## 10A RELAY CHANGE

In order to use the new gold contact telephone type relay in the 10A Exciter the following changes are necessary:

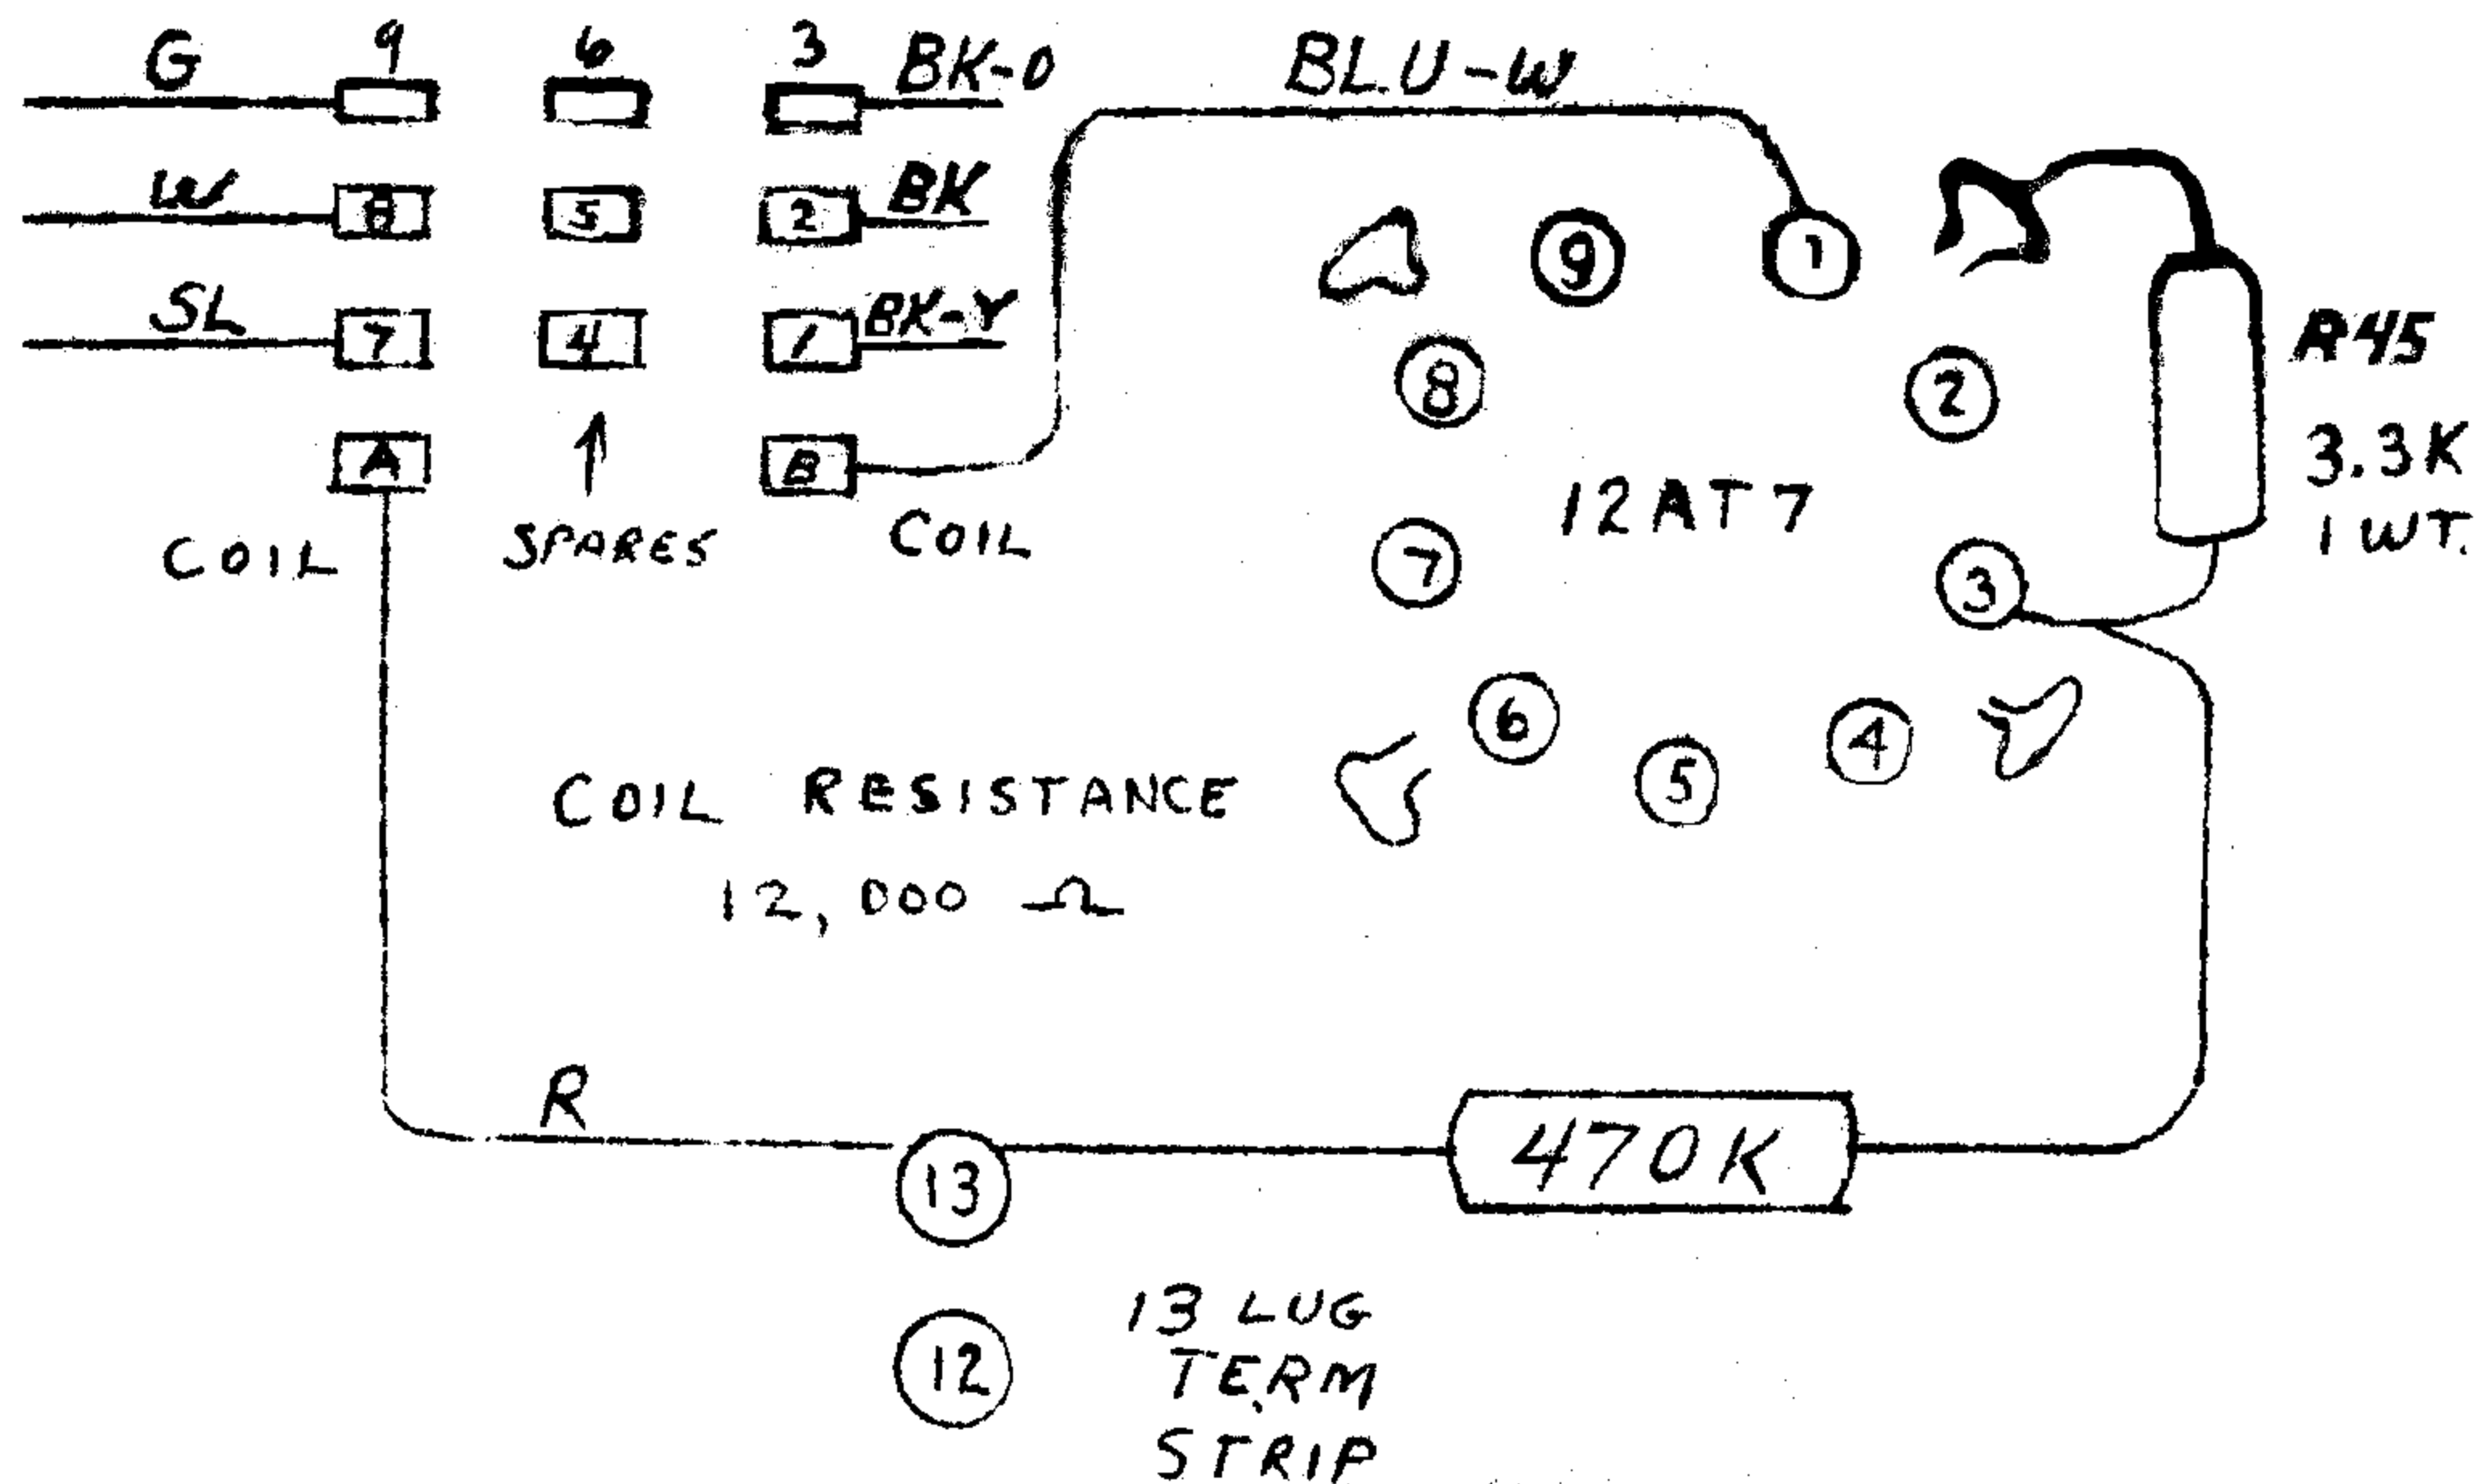
12AX7B Voice Amplifier and Relay Control tube should be changed to a 12AT7.

R45, 2.2K ohms should be changed to 3.3K 1 watt 5%.

R45 controls the resting relay current. In the event that the relay releases too slowly while operating with voice control, the value of this resistor should be increased slightly.

This relay should be connected as follows:
